APPLICATION FOR A RESIDENTIAL SITE IMPROVEMENT PERMIT/ CONSTRUCTION AUTHORIZATION FOR AN ON-SITE WASTEWATER SYSTEM, NEW WELL INSTALLATION, OR REPAIR OF EXISTING WELL

SOIL/SITE EVALUATION for ON-SITE WASTEWATER SYSTEM

IMPROVEMENT PERMIT DENIAL

Re: Application for Improvement Permit for property located at 7016 BRANDON PLACE RD , MECKLENBURG, NC 28227
Parcel No.: 13913456
Health Department File No.: SP26-064

Soil & Site Evaluation Map

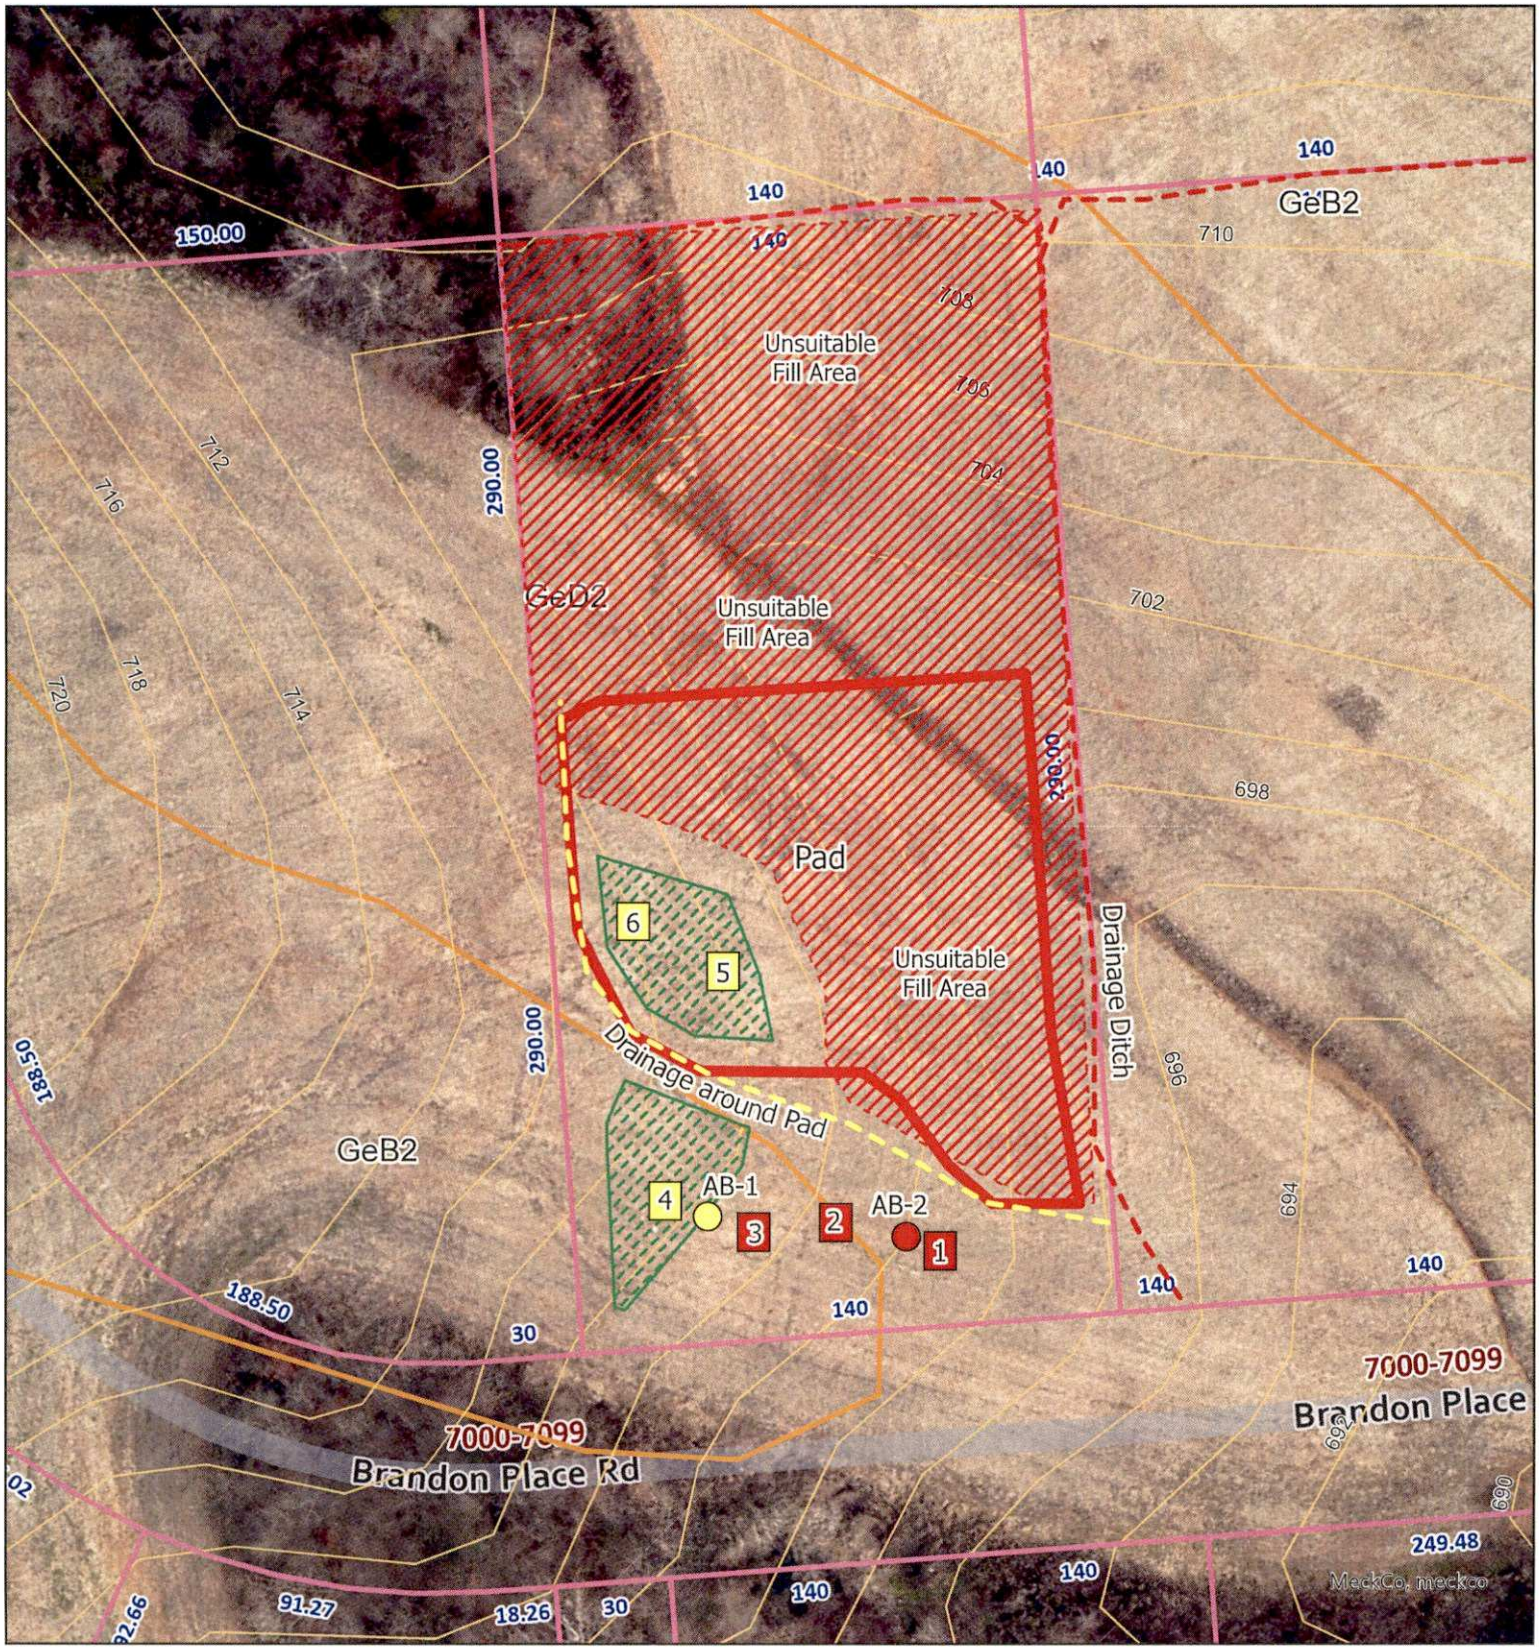
COMMENTS: Due to unsuitable soil depths, unsuitable saprolite, unsuitable fill materials, positive drainage around slab pad, and large unsuitable fill area there likely is insufficient space available to support a 4 BR SFR system and repair area.
